MAY 28 1985

Safety Evaluation Report
By The
Division of Fuel Cycle and Material Safety
Related to the
NRC Source Material License Renewal
for
Allied Corporation
UF₆ Conversion Plant
Metropolis, Illinois
Docket Number 40-3392
License Number SUB-526

Figure 6. Organizational Chart

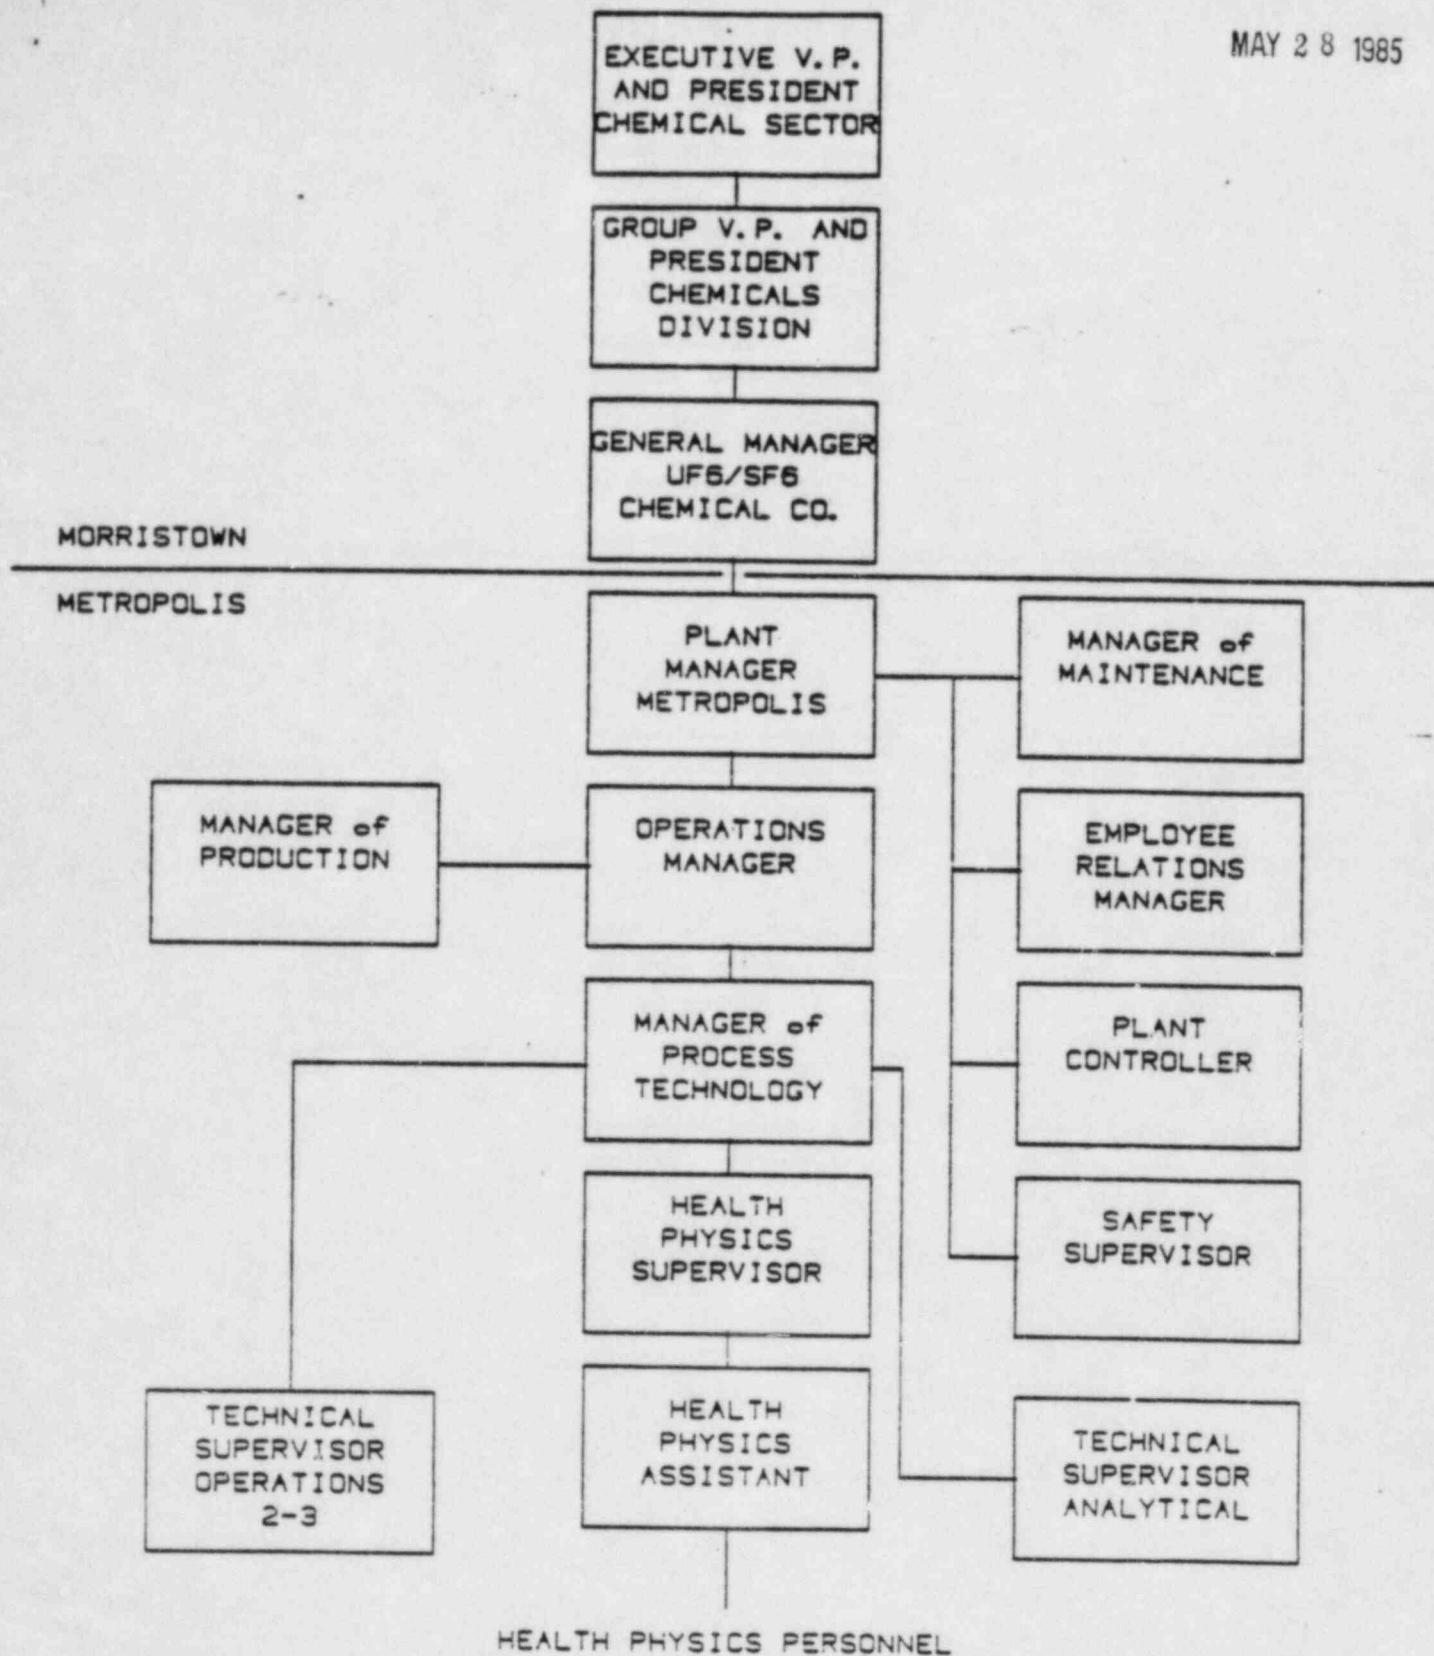
The Metropolis Works is owned and operated by the Chemical Sector, Allied Corporation. Operations at the plant are administered by a plant staff which is organized as shown in Figure 6. This organizational structure provides for separate lines of authority and reporting for the production and safety functions.

Operations are conducted at the Allied plant on a 24 hour per day basis. However, the health physics staff is present at the plant only during the first shift of each day. During the back shifts, the Health Physicist is on call should questions or an emergency arise. The lack of health physics staff during the majority of each day provides a situation in which technical assistance is not immediately available to plant personnel. The staff therefore recommends that the following condition be incorporated into the license to assure that personnel with a knowledge of health physics will be present at the plant at all times when operations are being conducted so that technical assistance and radiological monitoring capability are immediately available. A time period of 4 months for implementation of this condition is recommended to allow the licensee to recruit or train additional qualified staff.

12. Personnel with appropriate health physics training shall be present at the plant at all times when operations involving source material are being conducted. The licensee shall attain compliance with this condition on or before September 30, 1985.
